# Parts & Service Bulletin

<u>Parts</u>	Issue Date: April 06, 2010		
		Global Lit Num:	<u> CPGF</u> <u>- P -</u>	<u>00000071</u> - <u>2</u>
		Revision: 2		
		Revision Date: February 06, 2012		
Title:	PCC1301 (0327-1513-02) Control Board Obsolescence			
Region App	lies to:

#### Purpose:

Figure 1. Original design in which relays K7 and K8 were mounted on the PCC 1301

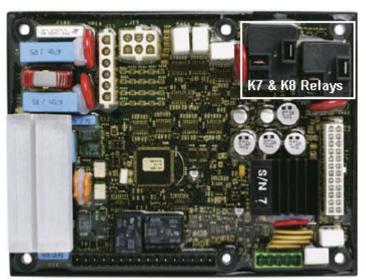
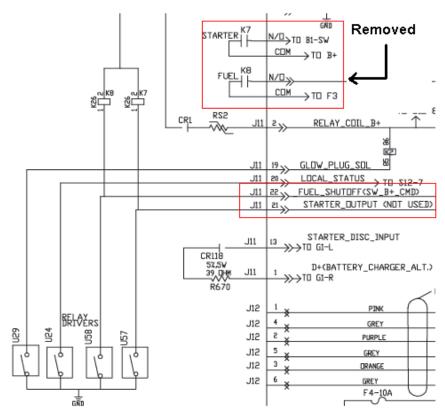
The 0327-1513-02 control board has been discontinued and replaced with the 0327-1513-01. The main difference between the boards is the 0327-1513-01 no longer has the K7 starter relay and K8 fuel relay mounted on the board. When replacing a 0327-1513-02 board with a 0327-1513-01 board, two DC relays need to be added to the harness to replace the K7 and K8 relays.

Since no revision has been made to the harness, these relays must be fitted to the harness by removing the corresponding wires from the connector and manually wiring the relays using spade terminals.

Figure 3. New schematic. Shows new pin-out for fuel shutoff and starter relays

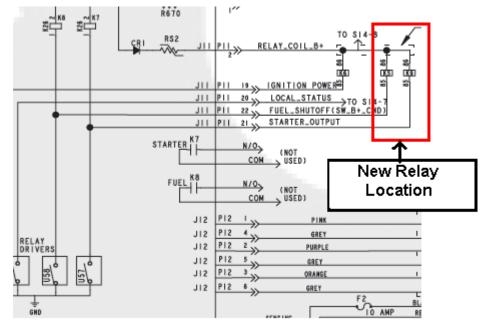
To install the starter relay, the ground-side of the relay coil must be connected to J11-21 and the positive-side connected to Relay Coil B+.

To install the Fuel Shutoff Relay, the ground-side of the coil must be connected to J11-22 and the positive-side connected to Relay Coil B+.

Load control by these relays differs depending on the genset model. Due to the unpredictable performance of smaller relays, it is recommended the 0307-2968-03 (12V) or 0307-2968-04 (24V), 30-Amp relays be used. This should provide sufficient current to the fuel shutoff pump and starter.
